Re: Juan Tabo Hills Estates-
Revised Sheet 61R
Hydrology File-M21D018; DRB 1005278; CPN 654887

SUMP INLET CALCULATIONS
For
Cattle Guard Grate at Blue Ribbon Road
(Juan Tabo Hills Estates, CPN 654887)

TITLE: JUAN TABO HILLS ESTATES
HUBBARD STREET S.E. & OFFSITE BLUE RIBBON
UTILITY PLAN & PROFILE

SCALE: 1" = 50'

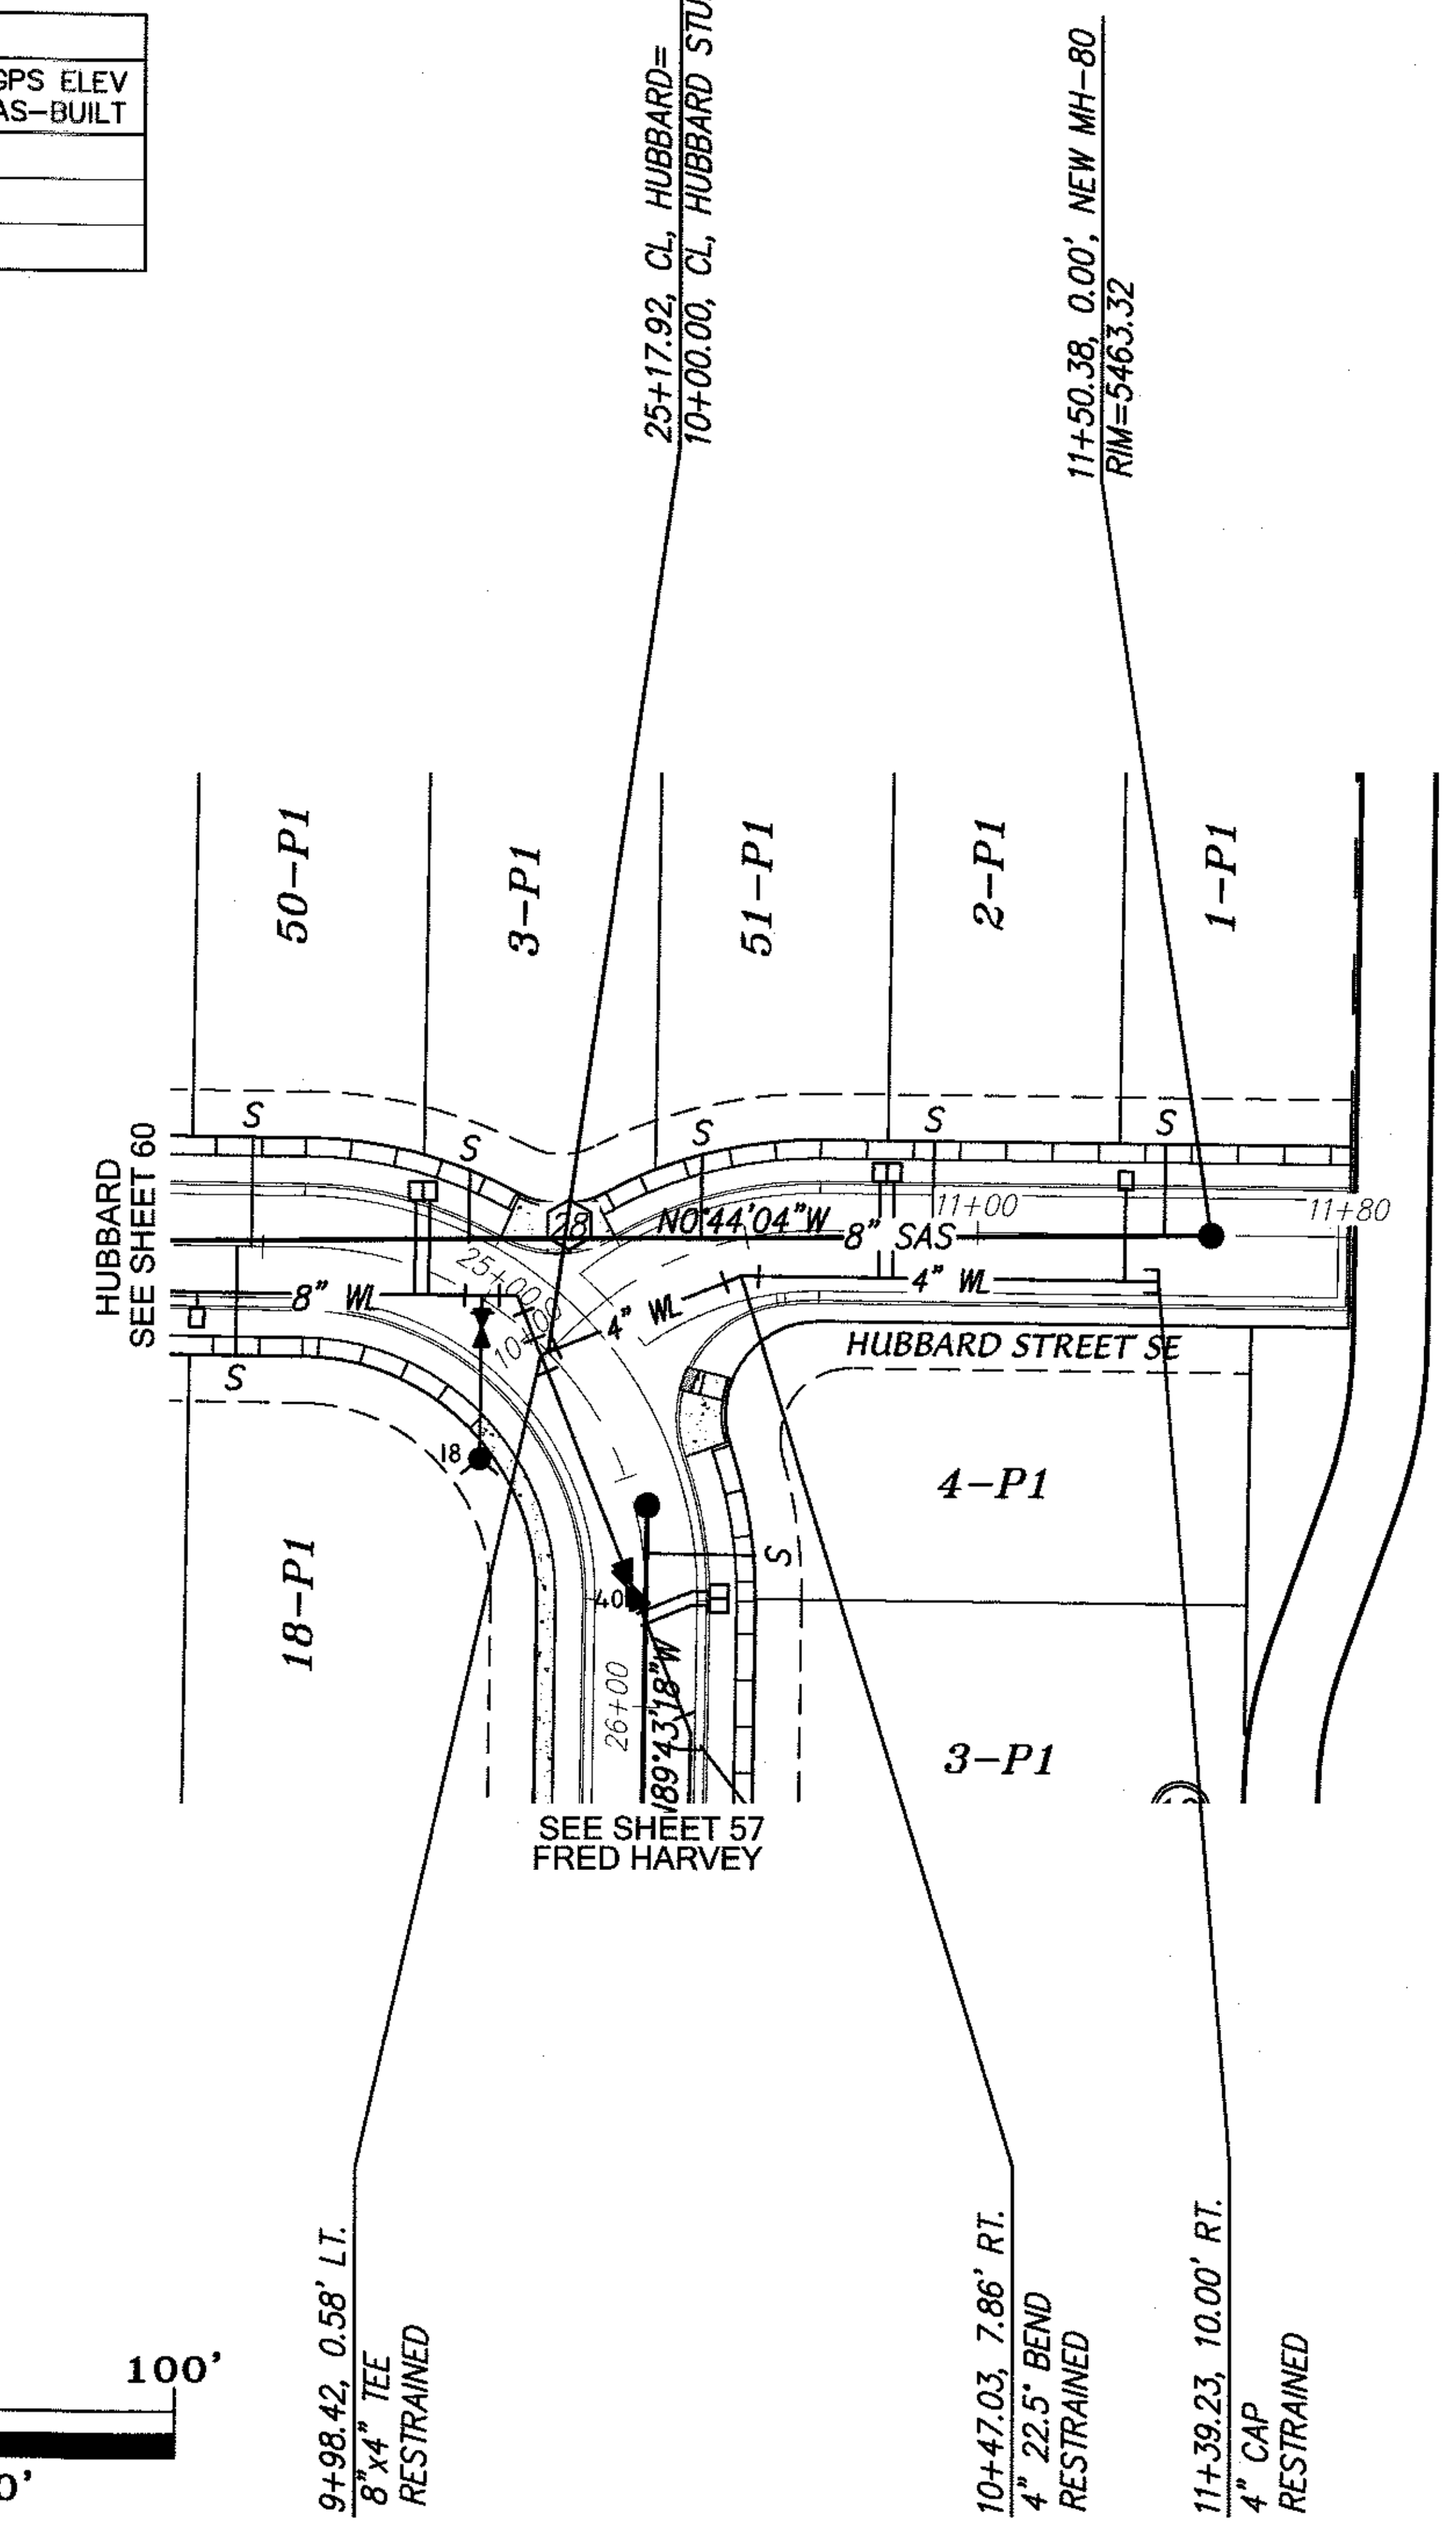
- The revision from two double-A inlets two double-D inlets needs to be supported with calculations demonstrating 2x 100-yr capacity for inlets in a sump using both the orifice and weir calculations.
- The change in inlet type should be noted in the change order request.
- Please put the HGL on the profile on sheet 61R.
- Please note that Easement R will need to be updated on the Final Plat to reflect the new storm drain alignment.

1. The double D inlets have been revised to a cattle guard grate that spans the roadway width. Only the weir equation calculation is necessary for this situation. The weir has almost 2 times the 100 year storm capacity, which should be adequate.
2. Okay.
3. Okay,
4. The final plat has already been revised.

BUILD NEW CATTLE GUARD INLET PER COA STD. DTLS. 2271 AND 2272 WITH FOLLOWING MODIFICATIONS:

1. NO CROWN IN GRATE.
2. DEPRESSED CURB & GUTTER ALONG WEST SIDE OF CATTLE GUARD INLET.
3. CONNECT 18" RCP AT SOUTH END.
4. CONNECT NW END TO 24" RCP.
5. CATTLE GUARD INVERT SLOPE = 1.0% SOUTH TO NORTH.
